# AP1000 DESIGN CERTIFICATION REVIEW

## Draft Safety Evaluation Report Open Item Response

DSER Open Item Number: 21.5-2 Item 19 (Response Revision 5)

DSER Open Item Number: 21.5-2NP Item 29 Revision 2

Figure F-12 ADS-4 Liquid Discharge Comparison

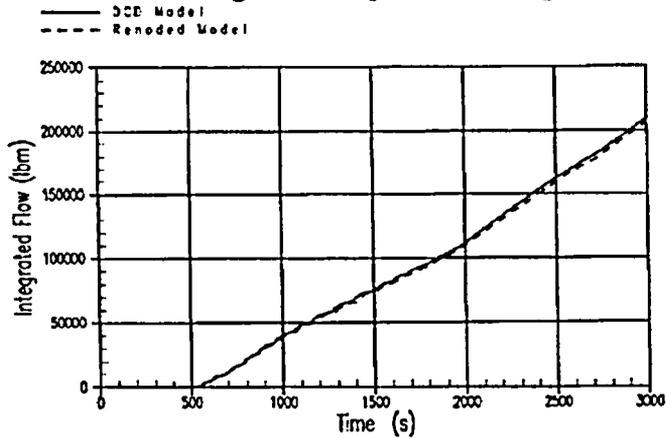
Correct Figure F-12 (i.e., Figure 21.5-1.12) for ADS-4 Liquid Discharge Comparison.

WCAP-15644 Revision 1 will be revised as shown below and issued as WCAP-15644 Revision-2.

Figure F-12 and Figure F-13 present the ADS-4 Integrated liquid and vapor discharges for the two cases respectively. Again, the differences between these two cases are considered to be negligible.

Figure F-14 Downcomer Pressure Comparison

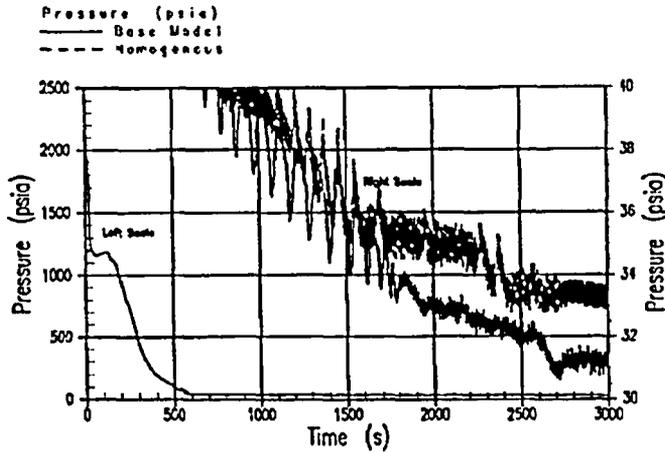
Correct text and Figure F-14 (i.e., Figure 21.5-1.14) to show Downcomer Pressure Comparison.

Figure F-14 presents a comparison of the upper downcomer pressure between the base and sensitivity cases. As can be seen, the sensitivity case results in higher upper downcomer pressure and subsequently results in delayed IRWST injection (Figure F-15). This can also be observed in the intact DVI line flow, which comprises all intact injection flow components (i.e. Accumulator, CMT and IRWST) per Figure F-16. As expected, the initial ADS-4 liquid discharge is much higher (Figure F-17) until the inventory which resided in the upper plenum and hot leg regions was depleted (Figure F-18). The net effect is a decrease in the ADS-4 vapor discharge rate (Figure F-19) and subsequently higher RCS pressures.
